# The Post-closure Radiological Safety Case for a Spent Fuel Repository in Sweden

An International Peer Review of  
the SKB License-application Study  
of March 2011

### Conceptual illustration of the radionuclide model for the biosphere (Figure 13-6 from TR-11-01)

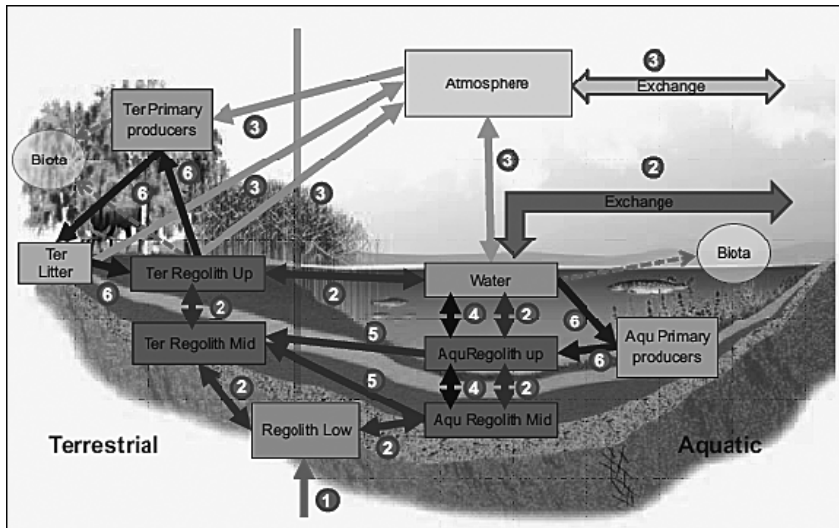
Radionuclides released to the lower regolith compartment are distributed to the upper layers of the ecosystems by advection and diffusion. The effect of radionuclide sorption on the advective and diffusive transport is taken into account by assuming equilibrium between the porewater and the solid phase of the different compartments. The model also considers the transport of radio-nuclides absorbed to suspended particles, driven by surface water fluxes, sedimentation and resuspension processes. The IRT finds this to be standard practice.

#### Distribution of dose from Ra-226 (and daughter radionuclides) originating from ingestion of contaminated food (Figure 12-3 from TR-10-09)

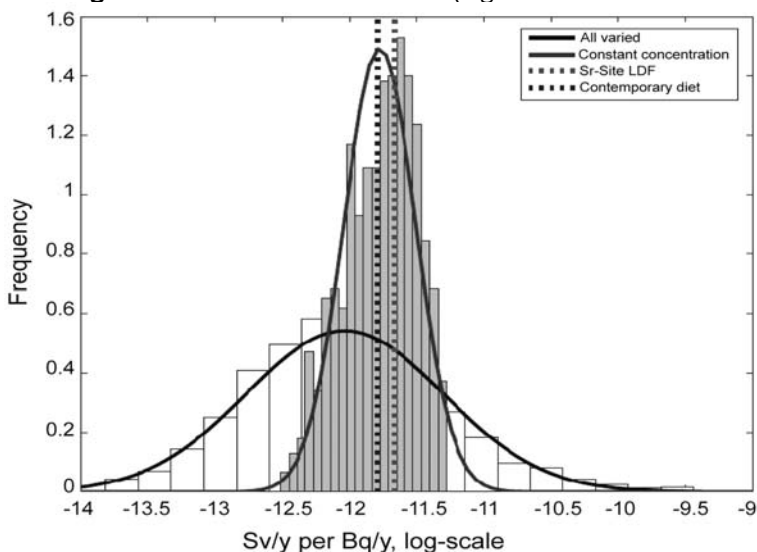
However, SKB notes that use of literature data “clearly exaggerate the uncertainty of Ra-226 retention at the site”. Thus, SKB decided to use the uncertainty in the Ra-226  $K_d$  estimated from the site data in the probabilistic simulations that addressed the effect of parameter uncertainty. The resulting LDF uncertainty spans several orders of magnitude as shown in the figure below. Given the importance of Ra-226 in the SKB assessment, and the lack of site-specific data for  $K_d$  values for Ra-226, the IRT encourages SKB to attempt to provide better site-specific data for future assessments if at all possible. SKB should also consider that such a large uncertainty in the Ra-226 LDFs could mean that better data would result in some other radionuclide or radionuclides dominating the overall dose rate to the most exposed group. This further underscores the usefulness of obtaining additional, site-specific data for Ra-226.

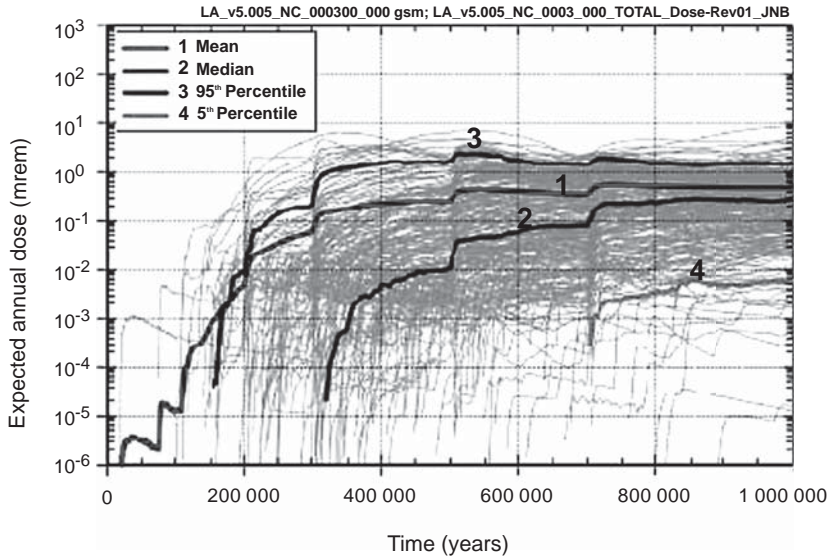
- It is quite surprising for a curve representing a mean to present such pulses at some precise dates in the future. A reader may not understand why the situation in for instance 299 149 years from now has to be so different from the one in 310 000 years.
- The resulting curve will notably change if another Monte-Carlo simulation is conducted. This means that the detailed features of the curve are not stable if they are recalculated. This is not in favour of traceability of the demonstration.

The IRT recommends that, to remedy this, SKB refine the realisations of the probabilistic underlying models that control the dates of canister failure (DFN model, sulphide concentrations, see Section 4.7.4 below). This can be done for example by performing more realisations of the DFN models or using methods such as the importance sampling Monte Carlo method, that allows to carry out more realisations in the end tails of the probability distributions, where canister failures occur, than in the median zone, where realisations result in a zero contribution to dose.
